DRAINAGE DISTRICT

- A. Request approval of Tentative Final Completion Certificate of Main Floodway Levee Segment 0-8 (3.13 miles).
- B. Request approval of Change Order No. 7 on the Contract with Ballenger Construction Company for the Construction of Common Levee/Anzalduas Dike Improvements, Hidalgo Loop Levee to Anzalduas Dam Project.

CHANGE ORDER NO. 16

Project No.	4410-01
Designed by	J.A.
Drawn by	H.R.V.
Checked by	R.S.
Sheet No.	C04-05

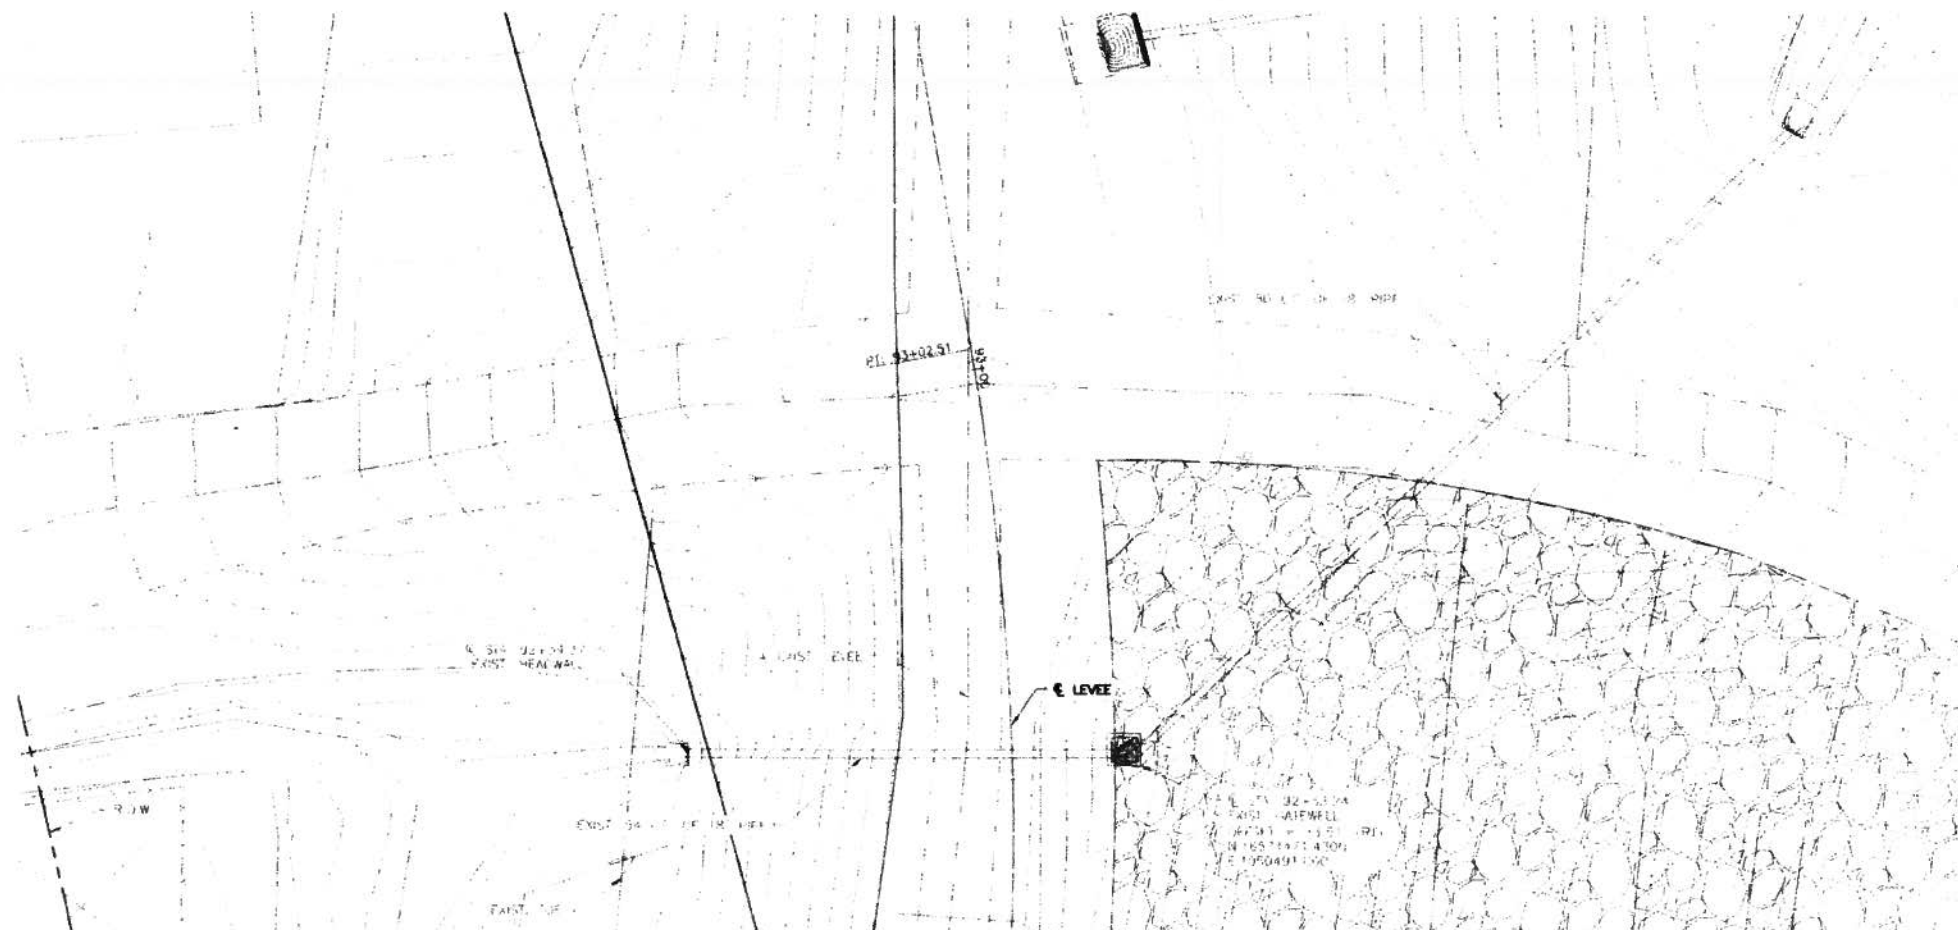
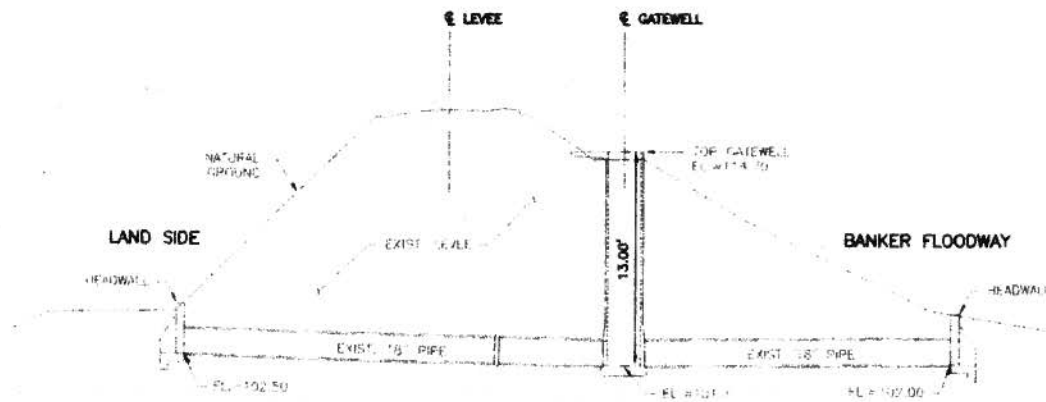
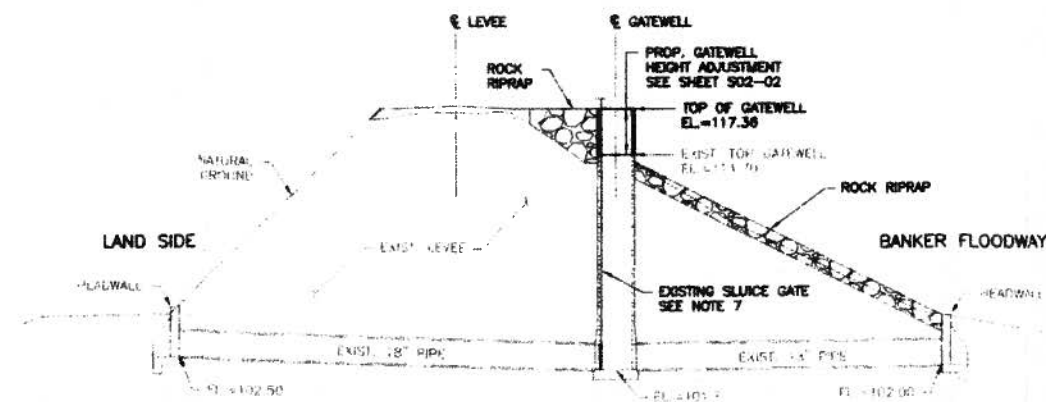
USIBWC has requested this structure be raised to the level of top of levee finished grade for better accessibility to Gatewell Structure No. 258.

Original "Engineer's Opinion of Cost" was estimated to be \$7,268.30. The Contractor's proposal was for \$13,543.09. An evaluation of the Contractor backup revealed that the Engineer had not considered the gatewell hatch in their estimate. After including an estimated cost for the gatewell hatch the Engineer revised his "Engineer's Opinion of Cost" cost to \$11,649.55. The Contractor accepted the Engineer's revised "Engineer's Opinion of Cost."

Engineer recommends processing of this Change Order for \$11,649.55 for a savings of \$1,893.54.
